Safety Evaluation Report

Related to the License Renewal of the
Point Beach Nuclear Plant Units 1 and 2

Docket Nos. 50-266 and 50-301

October 2005

Figure 4.5-1 Unit 2 Hoop Tendons, Projected Prestressing Force Trend

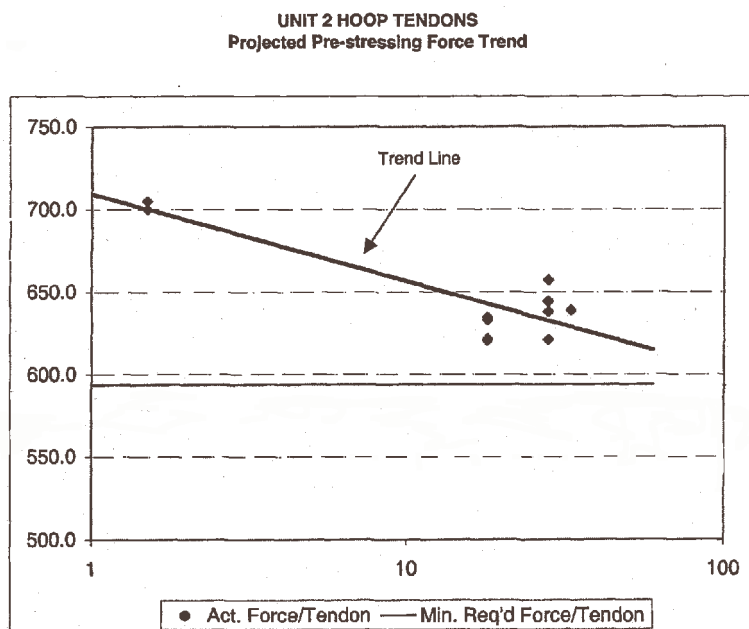
In response to RAI 4.5-1 items (2) and (3), the applicant provided the prestressing force plots with the trend lines of the projected prestressing forces for each group of tendons out to 60 years. The initial plots attached to LRA Section 4.5 were based on the lift-off testing of common tendons. This approach was not acceptable, as it was based on measurements of one tendon in a group. The staff recommended that the applicant develop the trend lines from all measured lift-off data, using a linear regression analysis. The applicant developed the trend lines using linear regression analysis and utilizing all measured lift-off force data. In its response, the applicant noted that this trend line information was based on draft calculations, and that the information will be resubmitted; if the final approved calculation revealed a different conclusion.

During a meeting on February 15, 2005, the staff indicated and the applicant agreed, that this response required further clarification. In its response, a clarification letter dated March 15, 2005, the applicant provided the corrected final plots showing the trend lines and the actual measured prestressing forces. Figure 4.5-1, shows a plot for Unit 2 hoop tendon reproduced for illustration purposes.

The staff found the process used in arriving at the trend lines to be in conformance with the provisions of NUREG-1800 Section 4.5.3.1.2 and, therefore, it is acceptable. The staff recognizes that the slopes of the trend lines could change as a result of the prestressing tendon measurements taken during future inspections. However, the applicant will evaluate the results pursuant to IWL-3221.1(c), and take corrective actions as stipulated in the LRA. The staff's concerns described in RAI 4.5-1 are resolved.
